CITY OF KIRKLAND

ADVISORY REPORT FINDINGS, CONCLUSIONS, AND RECOMMENDATIONS

To: Eric R. Shields, AICP, Planning Director
From:  Désirée Goble, AICP, Project Planner
Date: July 17, 2008
File: ZON06-00025 SABEGH STREAM AND BUFFER ENHANCEMENT PLAN

SITE PLAN scale: 1" = 20'

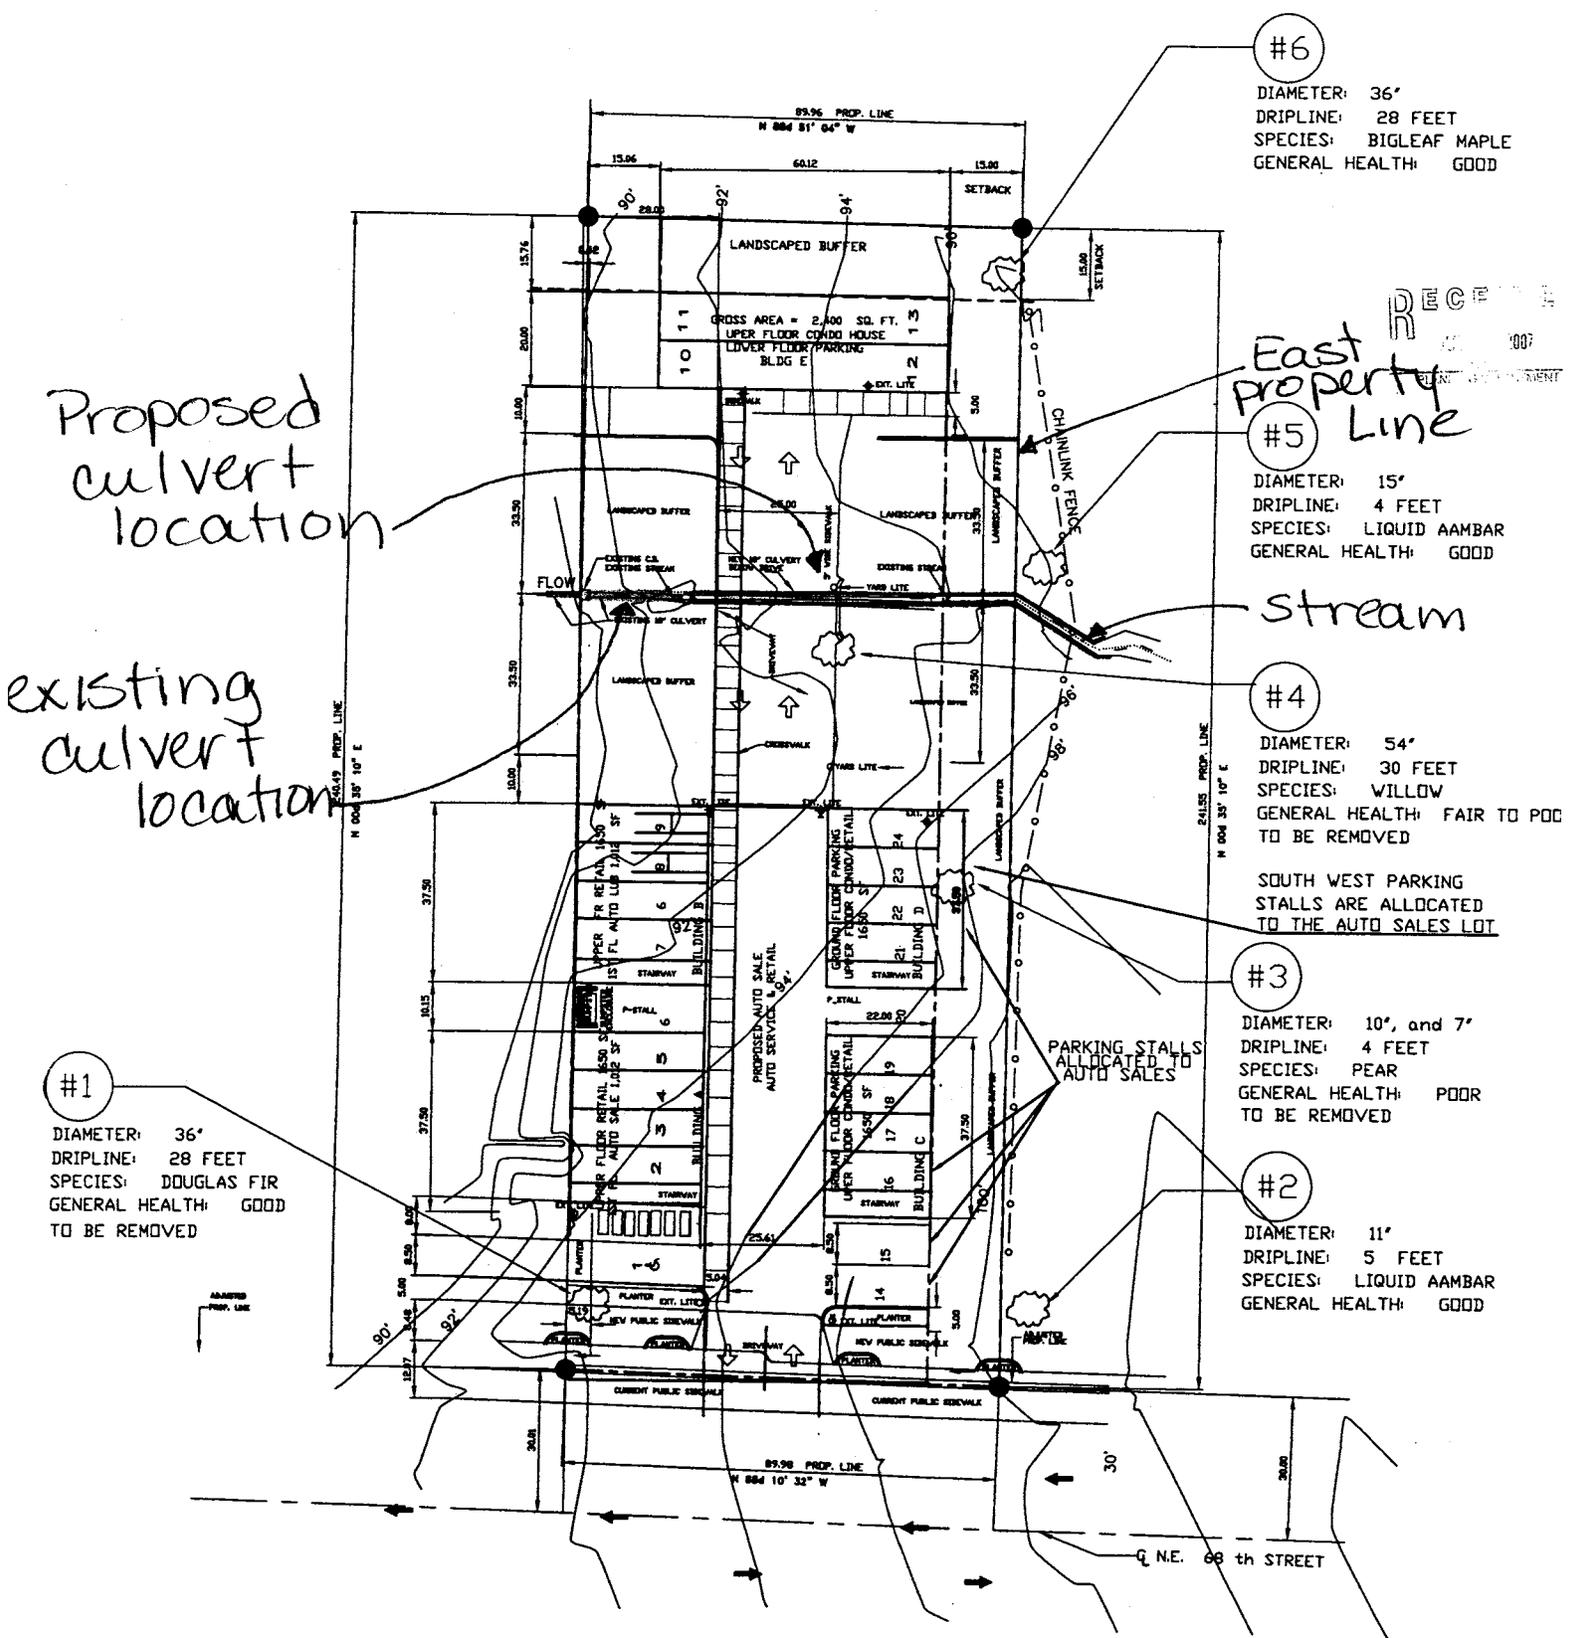
- b. Conclusion: The portion of the property north of the stream contains approximately 6,750 square feet, a culvert/bridge is necessary to provide access to the north. The applicant has only considered site design in the placement of the culvert. The applicant should relocate the driveway to the west side of the property to minimize the amount of stream that will be located in a culvert. The applicant could redesign the project to locate the entire driveway and pedestrian access along the west property line.

- (3) The mitigation planting areas shown to the west of the proposed access road would essentially be buffering a piped stream section. As such, they would offer little in the way of buffer functionality to either the piped section or the remaining open channel section upstream, now on the other side of the proposed access road.

- (5) Karen Walter, Watersheds and Land Use Team Leader, Muckleshoot Indian Tribe Fisheries Division (see Attachment 7.1) stated that "... the applicant should relocate the proposed culvert to the western portion of the site to provide access to the northern portion of the parcels. Nowhere in the materials could we find the applicant committing to this recommendation. This approach would minimize the project's impacts with respect to a needed stream crossing. Anything less will negate the buffer modification and cause additional adverse impacts to the affected stream that could be otherwise avoided."

- c. The installation and maintenance of the mitigation plantings shall comply with the provisions of KZC 95.45.12 (see Conclusion II.F.1.b).
 - d. Relocate the driveway and pedestrian access to the west side of the property or submit written authorization from the adjoining property owner(s) to the west agreeing to the removal of the stream from the existing culvert (see Conclusion II.F.3.b and II.F.5.b).

Sheet 1/3
 Job #06546
 Drawn by: L. Emenhiser
 Date: January 19, 2007
 Revision #3: November 1, 2007

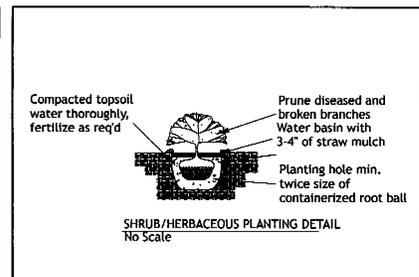
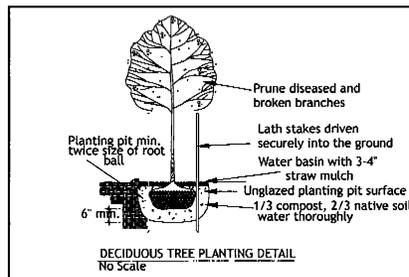
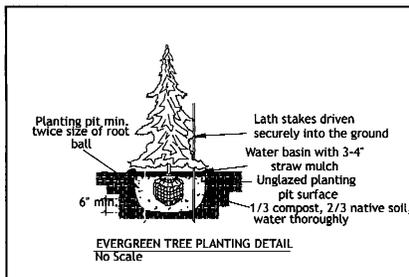
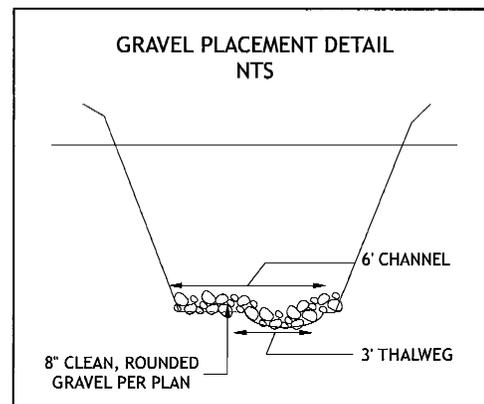
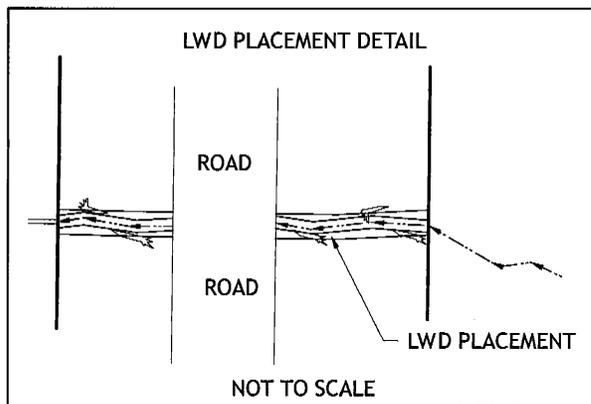
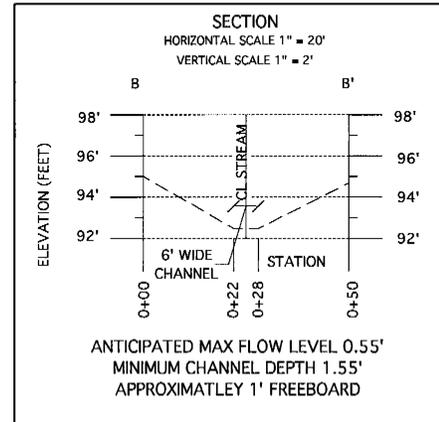
- 2) Buffers are smaller than allowed under buffer modification. While the scale on the sheet 1/3 is wrong (1 inch actually measures 31.6 feet on the scale bar, not 30 feet as listed), the buffers measure only one inch on the south side and 0.95 to 0.96 inches on the north side of the stream. This is under the 33.5 feet required under either the scale bar or the stated 1" = 30' stated scale. On sheet 3/3 no scale bar is shown so there is no way to check the accuracy of the scale. However, at 1" = 10' the buffers areas measure only 31.5 to 32 feet wide – again, smaller than the minimum buffer modification width of 33.5 feet. Buffers must be measured from the stream bank, which is now shown as 6 feet wide.

- 7) Sheet 1 of 3 is difficult to interpret. For instance, there are no clearly marked areas for parking. Some buildings have bisecting lines and others do not. There are call-out arrows with no associated text. What could be sidewalks are shown as a series of short, disconnected parallel lines.

- 13) The proposal should offer a contingency plan if sediment accretion aggrades the channel and again causes flooding problems.
- 14) The plan view drawings on the first sheet of the mitigation plan conflict with each other and with the proposed square footage quoted. For instance, the top right (northeastern) buffer quadrant measures 37 feet wide on the 10-scale drawing, but only 26 feet wide on the 30-scale drawing – a difference of 11 feet. Neither drawing appears to match the quoted planted area figure of 4,368 square feet.

Sheet 2/3
 Job #06546

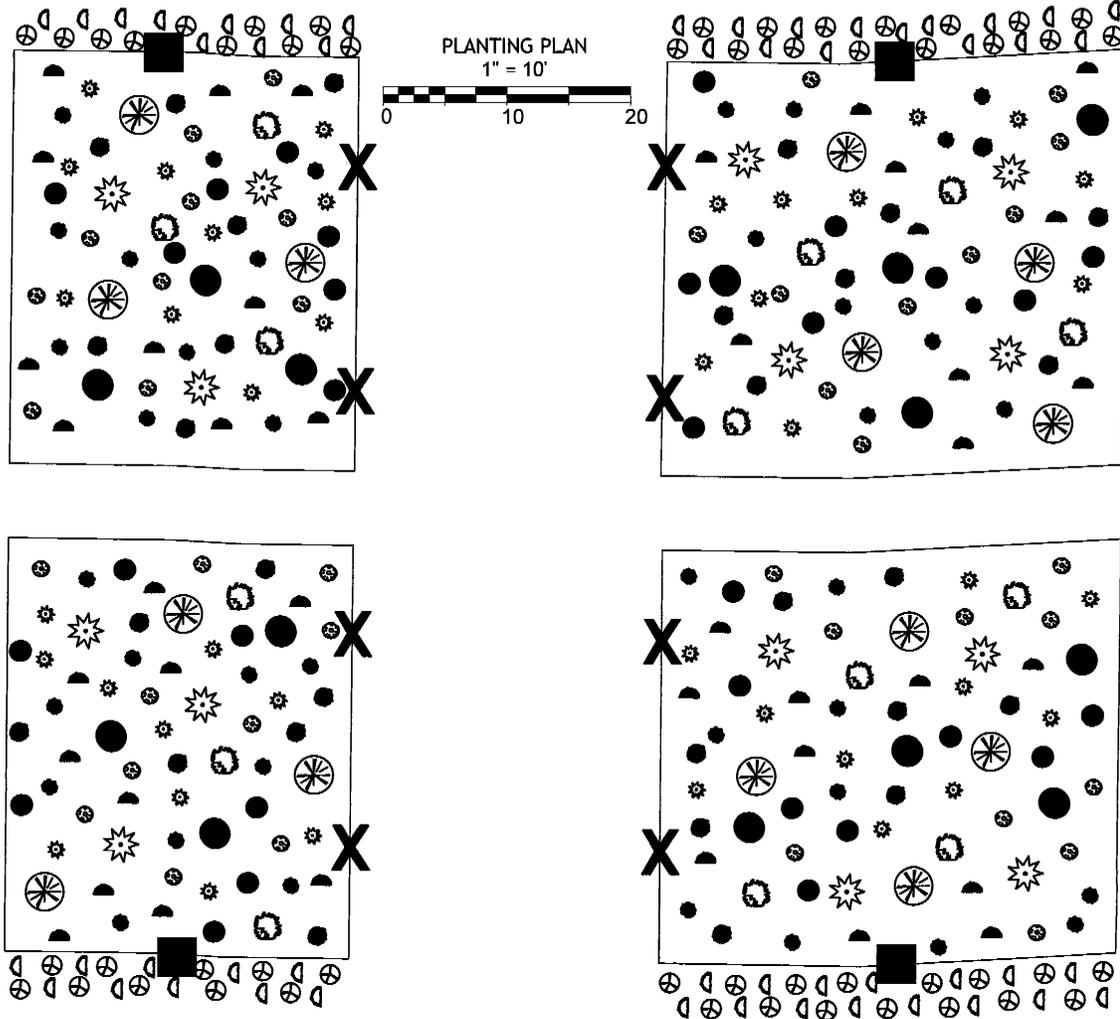
- 2) Page 1 of the report describes a split rail fence to demarcate the buffer edge. This is inconsistent with page 7 of the report and sheet 2 of the mitigation plan, which describe a shrub barrier of equivalent barrier value. The density of the shrub barrier plantings is higher than in the last proposal. However, as stated in my first review, while a shrub barrier technically meets the requirements of KZC 90.95, a split rail fence will not only be more effective in the long run, but also will likely be cheaper and easier to install compared to installing and maintaining shrubs as required to offer a barrier of equivalent value. KZC 90.95 states that the barrier be placed "between the upland boundary of all stream buffers and the developed portion of the site." In this instance, the shrub barrier is included within the reduced buffer, rather than outside it, as required.
